RETREAT AT TIMBERRIDGE FILING NO. 2

CONSTRUCTION DRAWINGS

MARCH 2021

RETREAT AT TIMBERRIDGE FILING NO. 2
CONSTRUCTION PLANS
GRADING & EROSION CONTROL PLAN

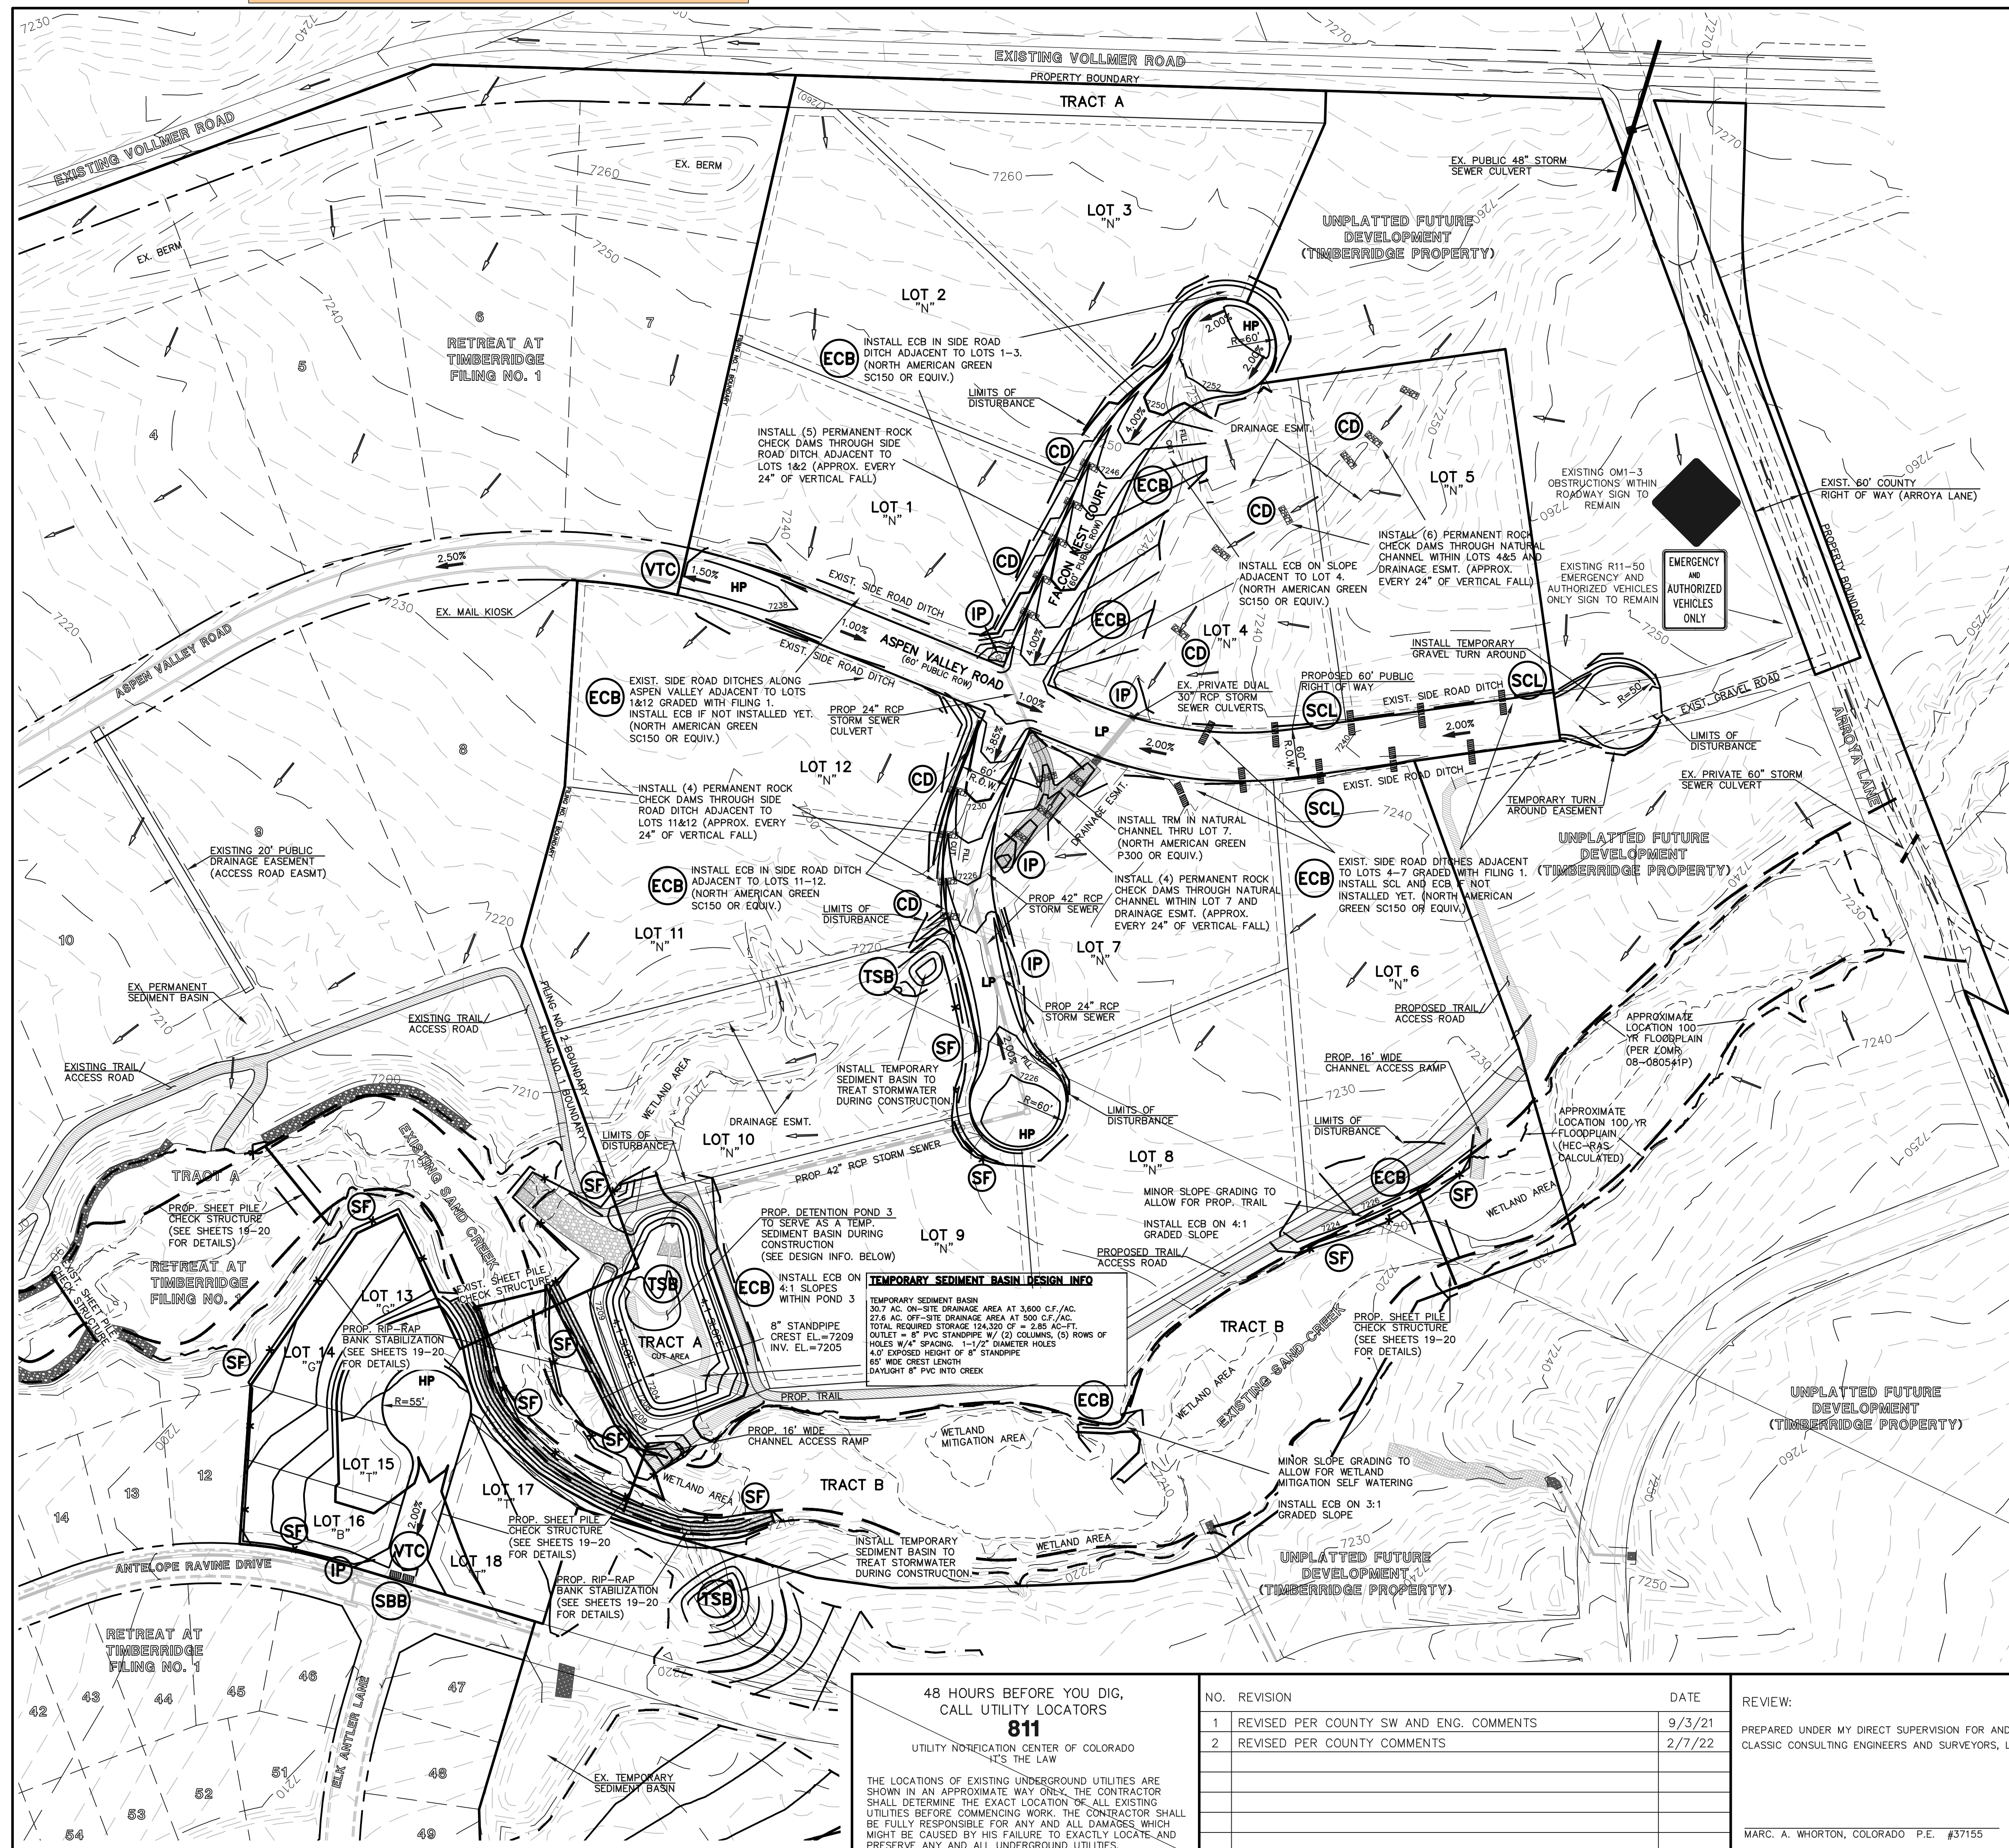
Show all Runoff Reduction RPA areas in drainage easement or no build easement (see Drainage Report for additional information), unresolved.

TEMPORARY SEDIMENT BASIN DESIGN INFO

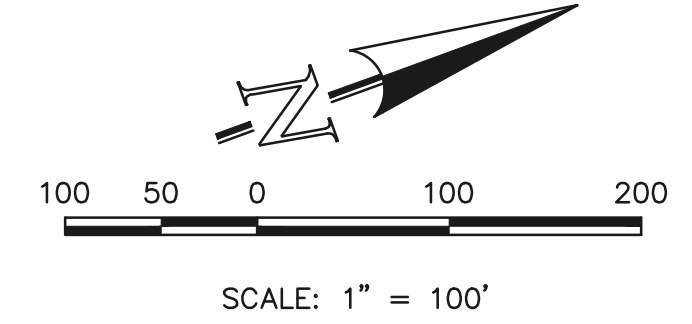
Provide details of temporary sediment basin including riser pipe perforation sizing, number of rows, required volume, location of outlet and spillway, and tributary area to the sediment basin.

RETREAT AT TIMBERIDGE FILING NO. 2
 CONSTRUCTION PLANS
 GRADING & EROSION CONTROL PLAN

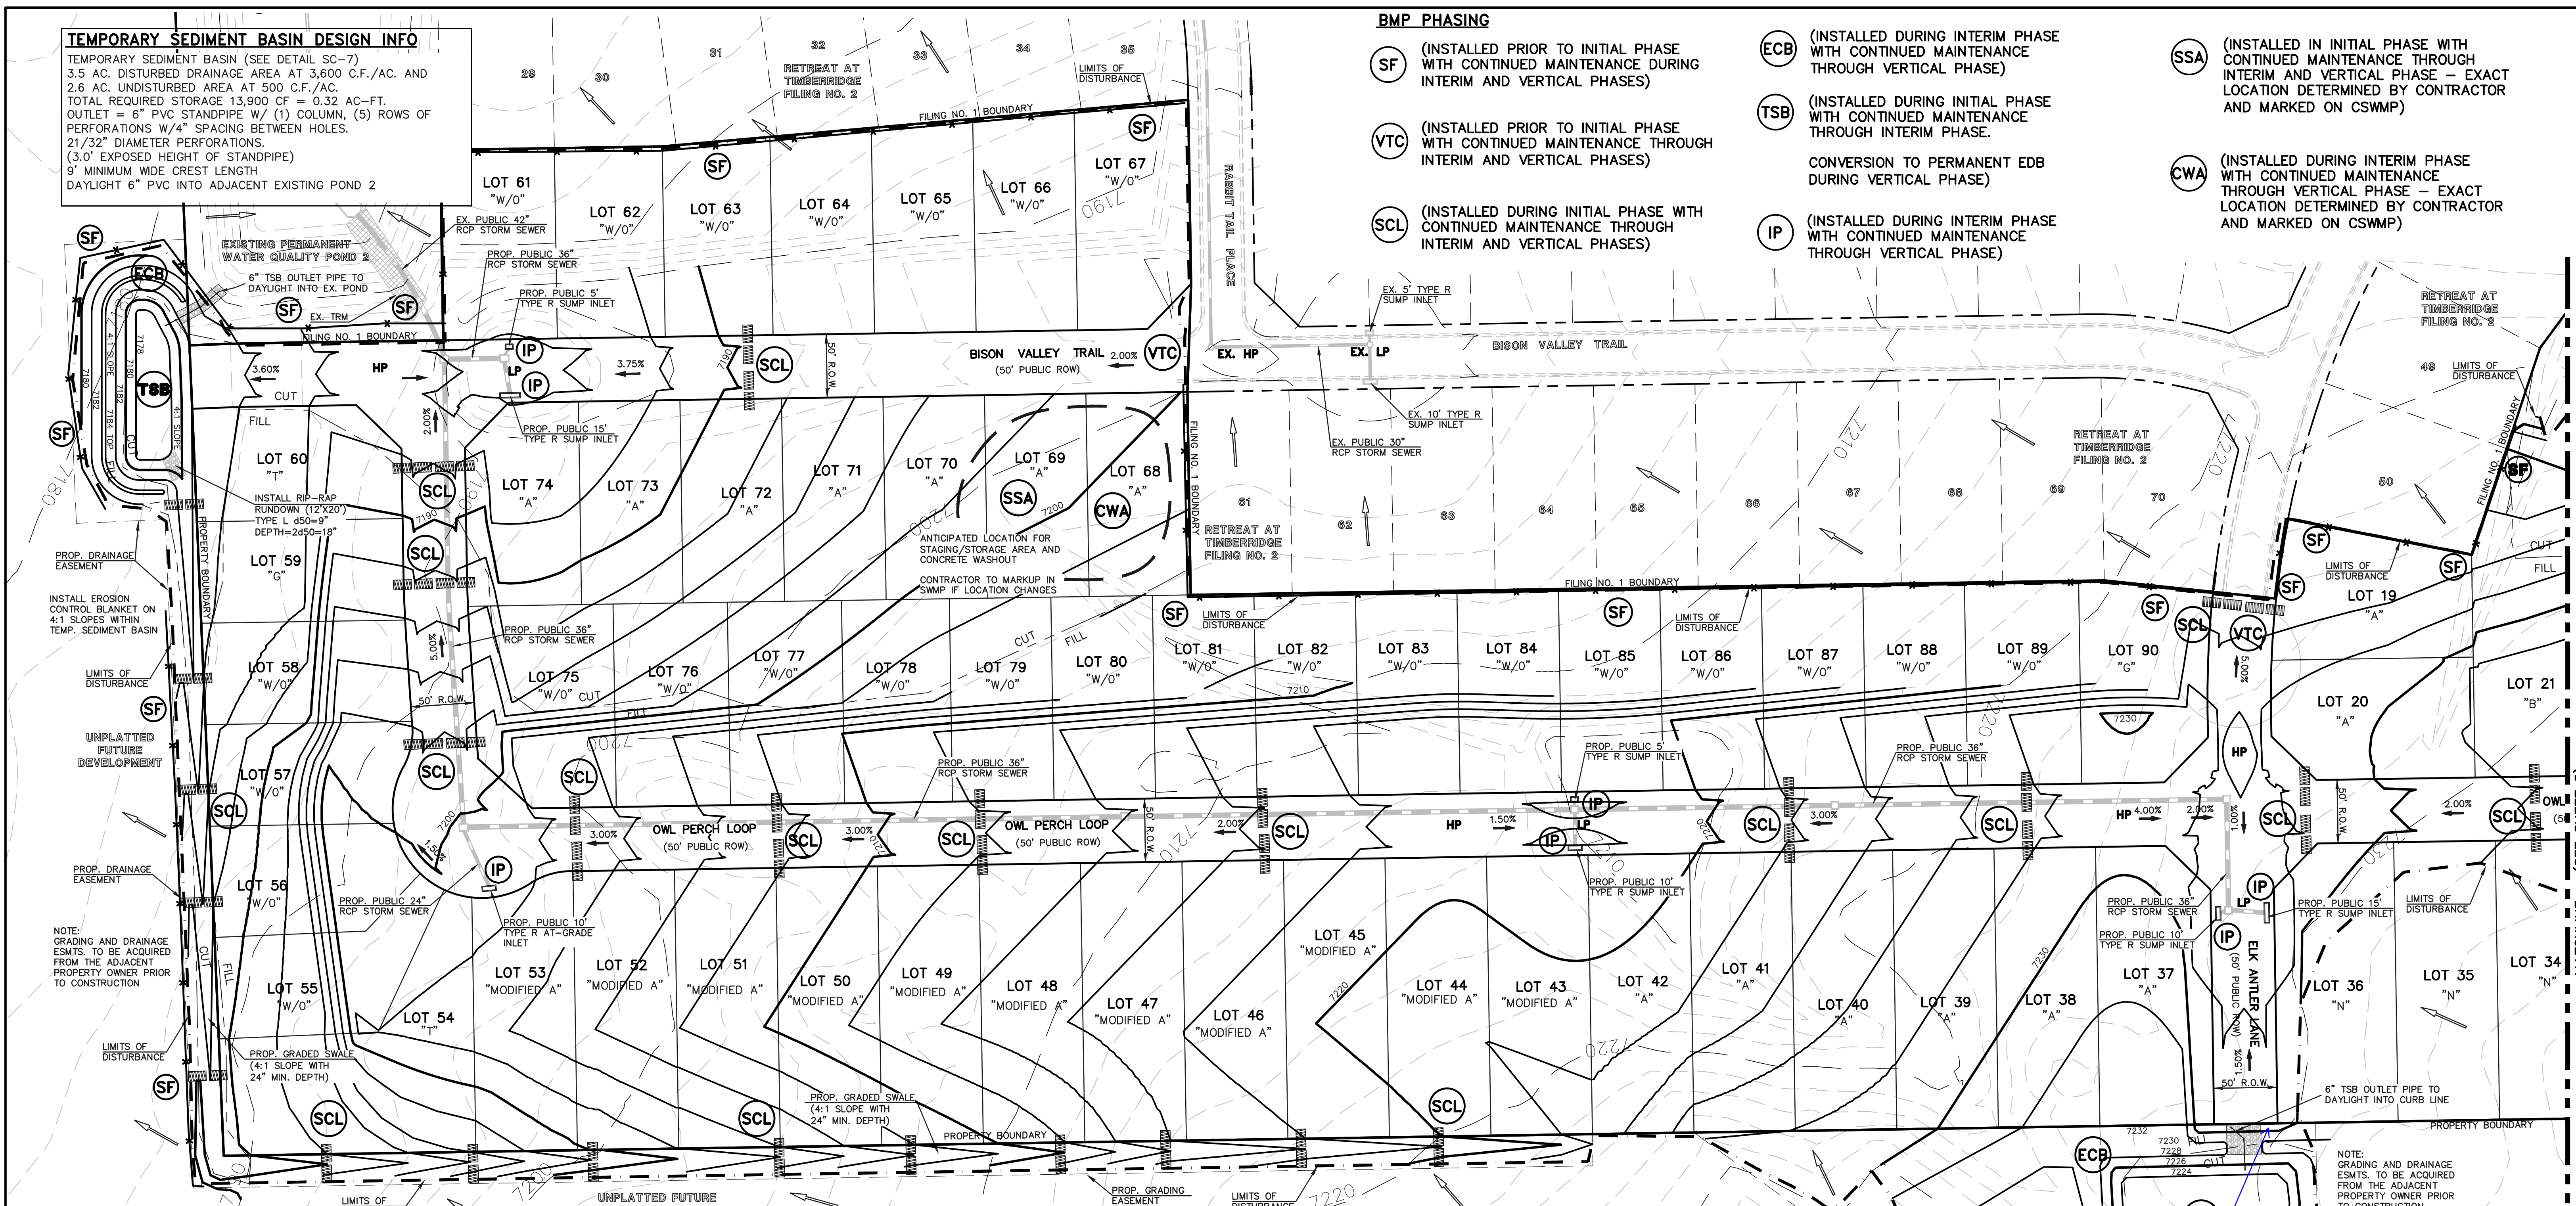
This can be a temporary sediment trap since its treating such a small area.

Show where the temporary and permanent outlet pipes will release flows (into an inlet?).
 Curbline appears to be 5' higher than the pond bottom.

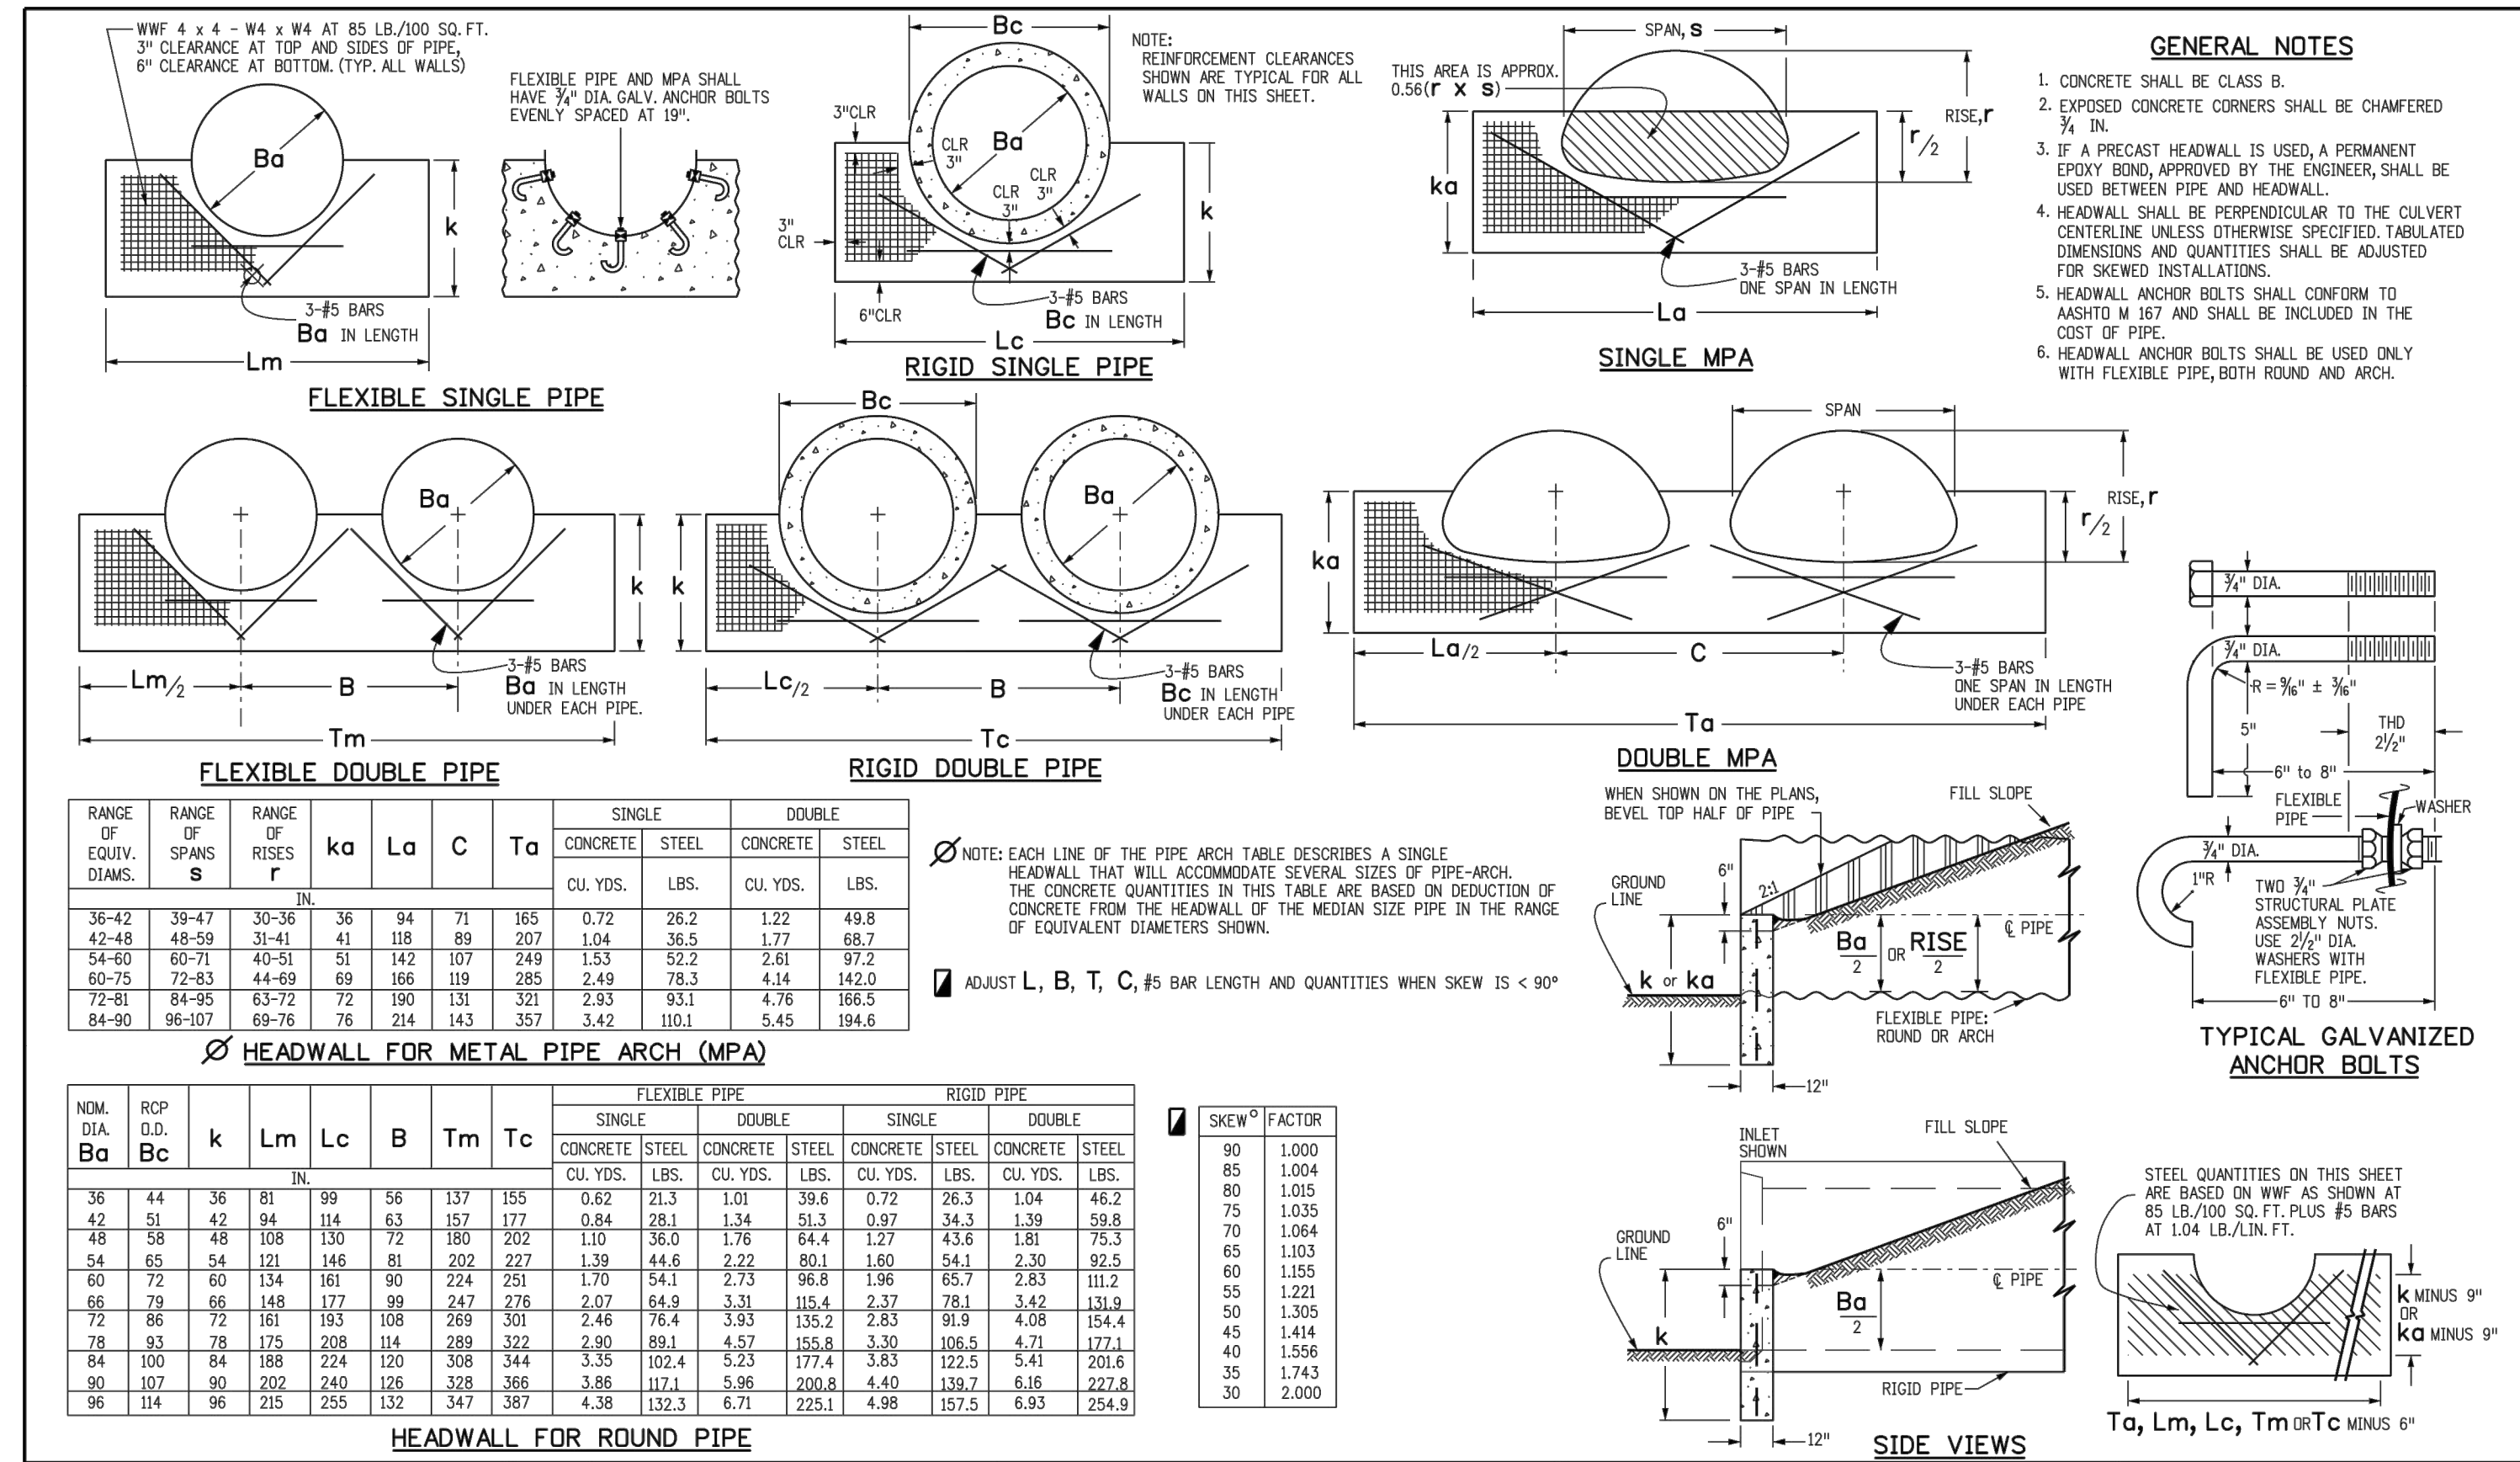
Include CDOT dtl M-601-12 for concrete headwall
